BARR ENGINEERING CO.
CONSULTING HYDRAULIC ENGINEERS

Re: Morningside Area Storm Sewer

MISC. STRUCTURES
REVISED
EDINA IMPROVEMENT
NO. 111

TIED BID
PROPOSAL
VILLAGE OF EDINA, MINNESOTA
STORM SEWER
IMPROVEMENT NO. 111

SOIL BORING LOCATION

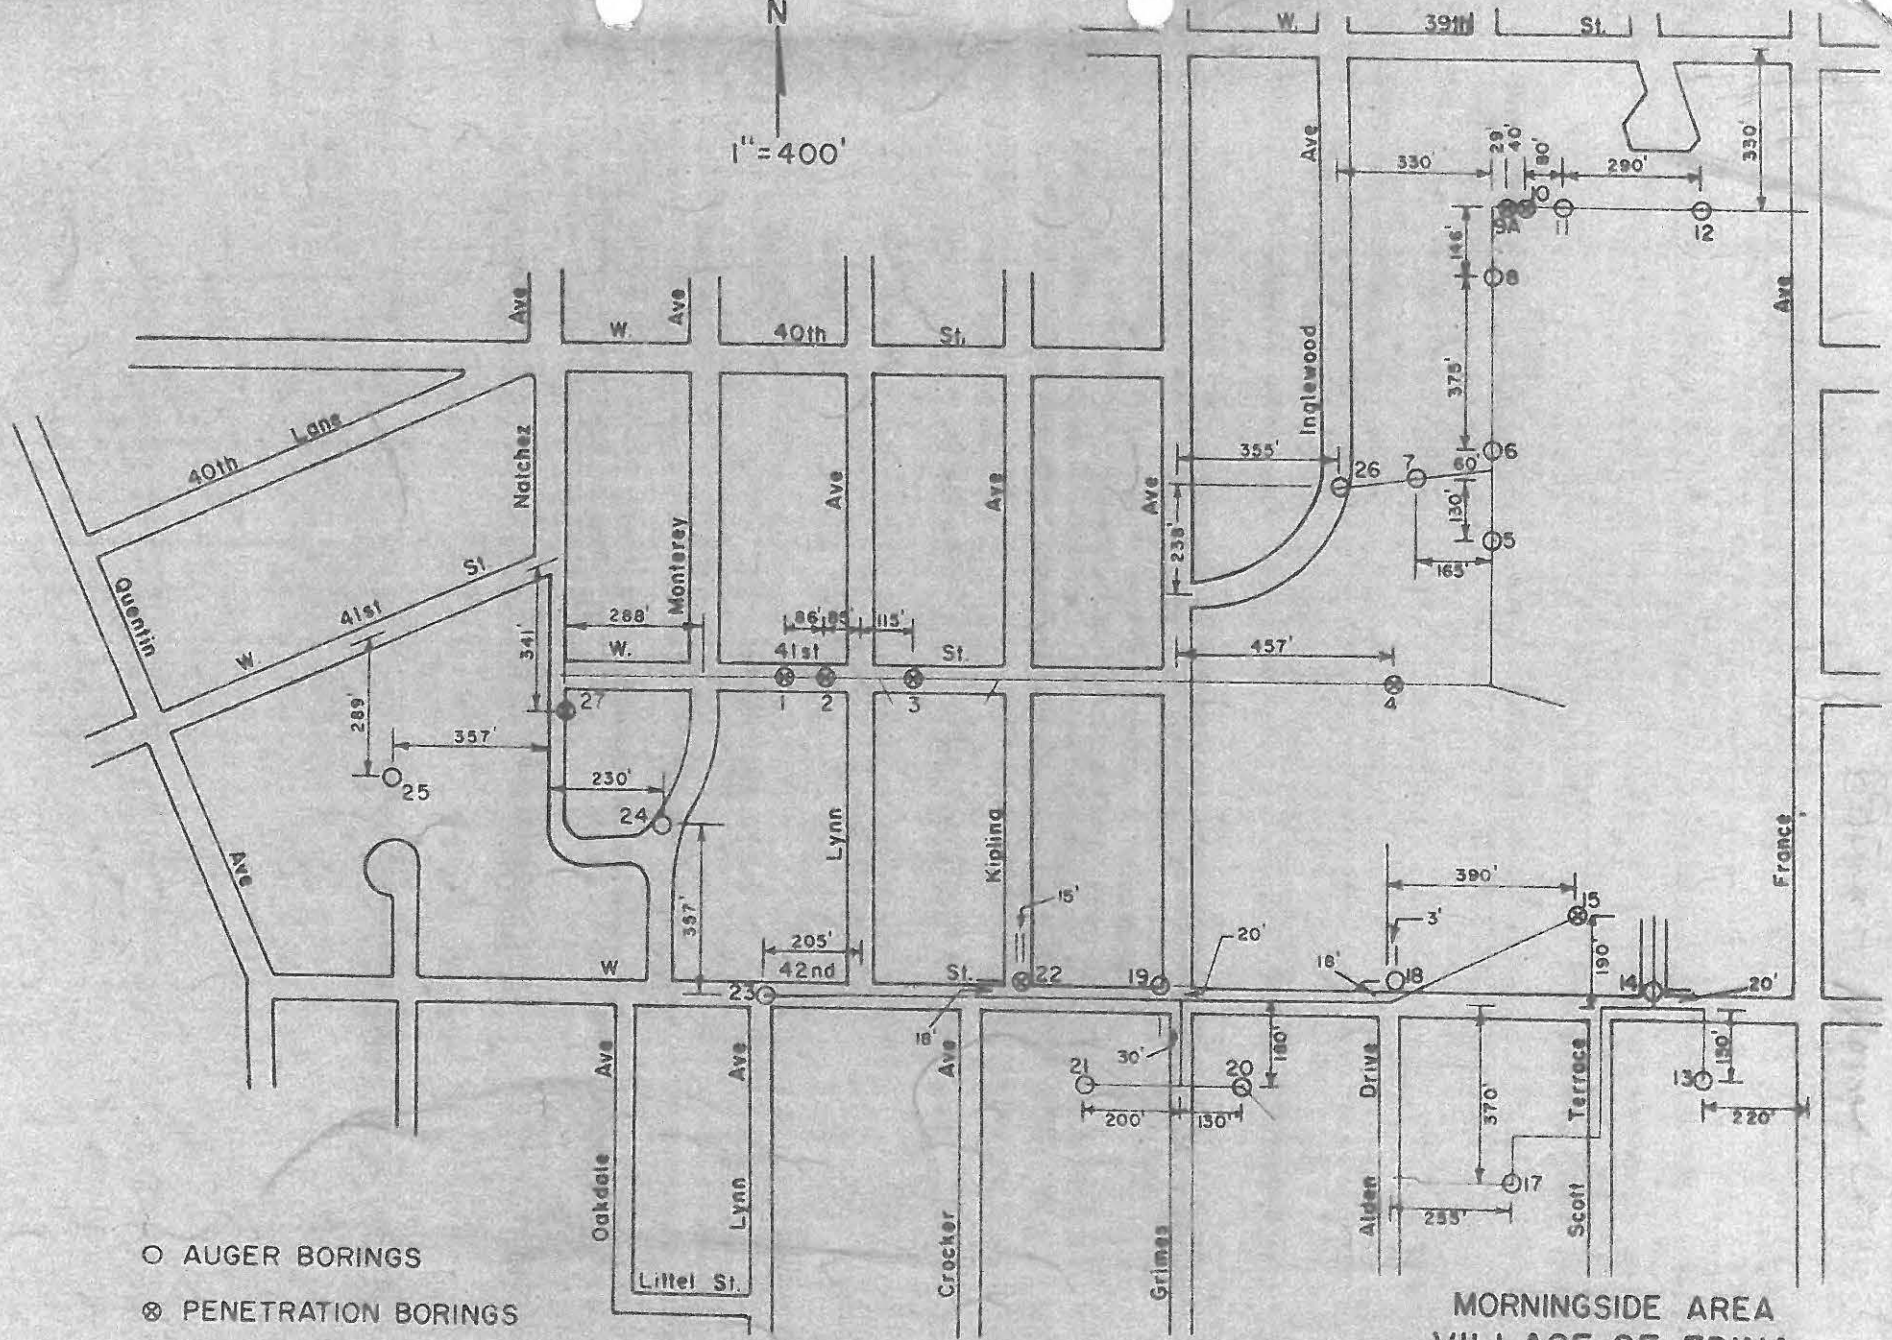
We have added the locations of borings 24, 25, 26 and 27, which were taken by your crews on January 16th and 17th. Since you continued with the numbering system used in your report of December 21, 1967, we would prefer to have the boring logs and soundings from the recent work included in the December 21 report. We are therefore returning four copies of the report for the insertion of the additional data.

Boring 24	-	Elevation 871.2
Boring 25	-	Elevation 870.9
Boring 26	-	Elevation 866.9
Boring 27	-	Elevation 870.6

Also, would you please check the vertical scale noted on the top of the log sheets for borings 9A and 10.

INUNDATION STRUCTURES

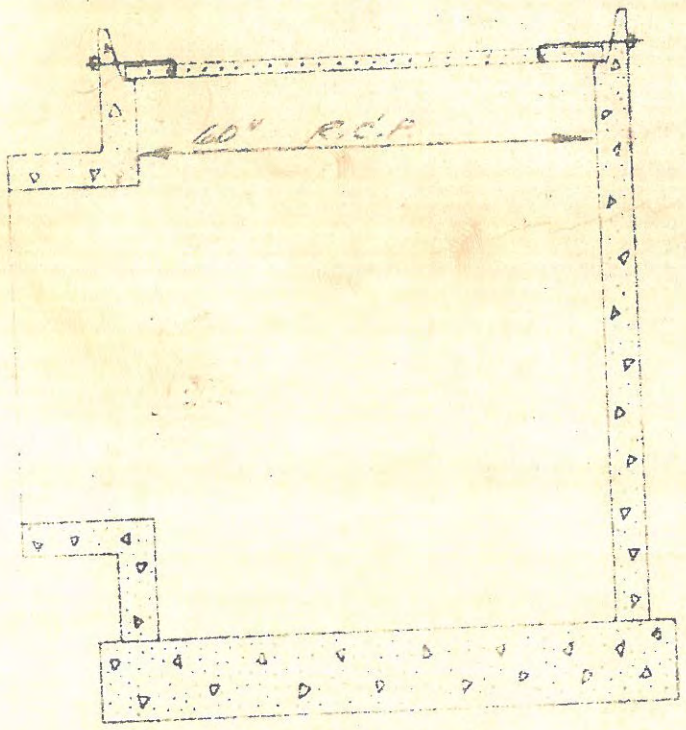
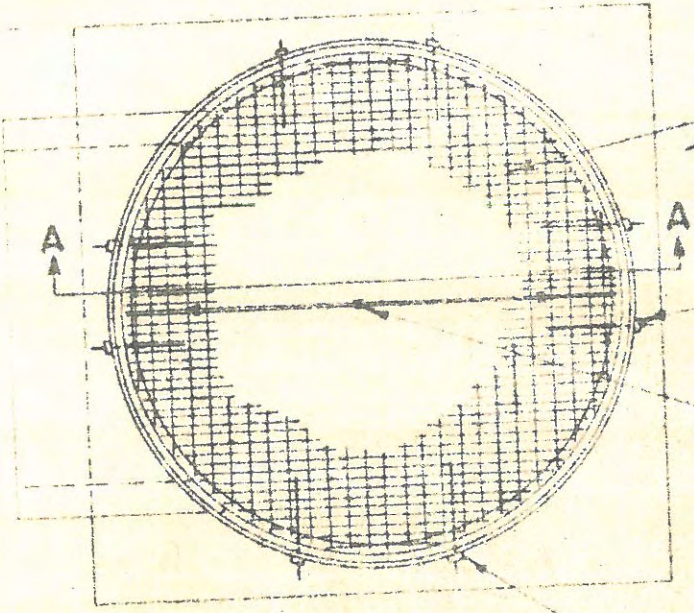
In accordance with your request we have prepared a sketch of a revised detail for the structures in the inundation area for the above referenced project. If you have any questions concerning this sketch, please call me.
